Safety Recall

Code: 74D9

Subject Passenger Occupant Detection System (PODS)

Release Date August 27, 2019

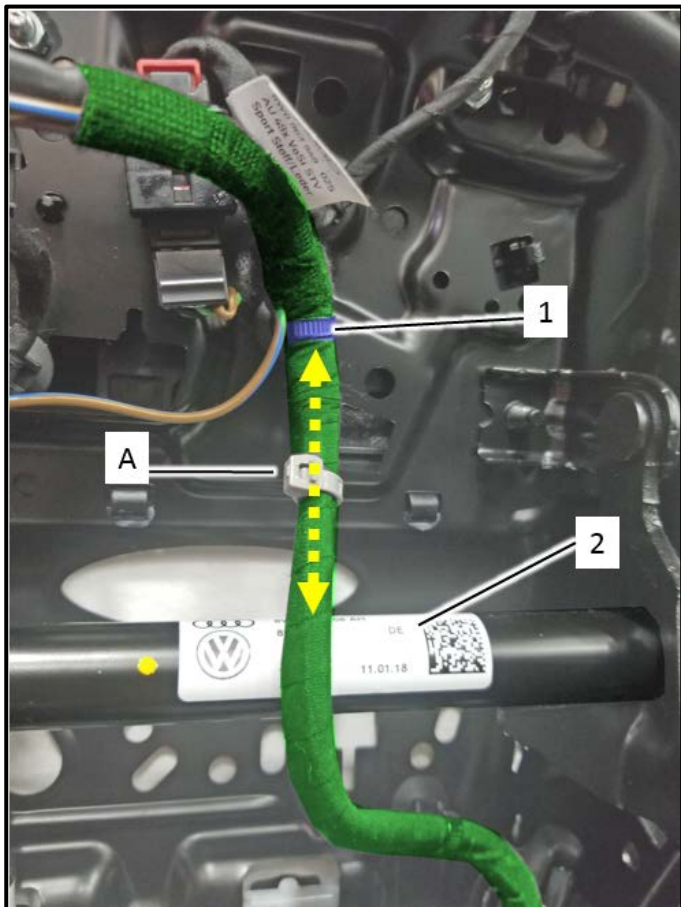
- The seat does not require removal for this repair.
- DO NOT ATTACH THE HARNESS TO THE SEAT FRAME. The cable ties are only applied to the wiring harness.
- New cable ties <A> and are applied to the PODS control module wiring harness in the areas shown.

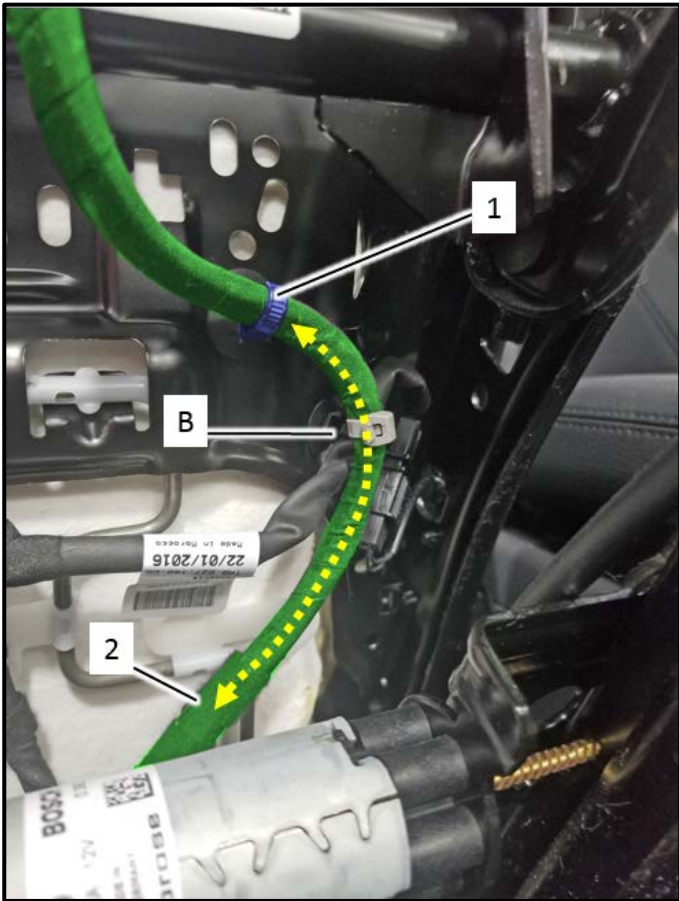
- Attach the first cable tie <A> in the yellow marked area between the securing clip <1> and the seat frame cross bar <2>.
- Cut off the excess cable tie material.

- Attach the second cable tie < cable B > in the yellow marked area between securing clips < 1 > and < 2 >.
- Cut off the excess cable tie material.
- Move seat back to its original position.
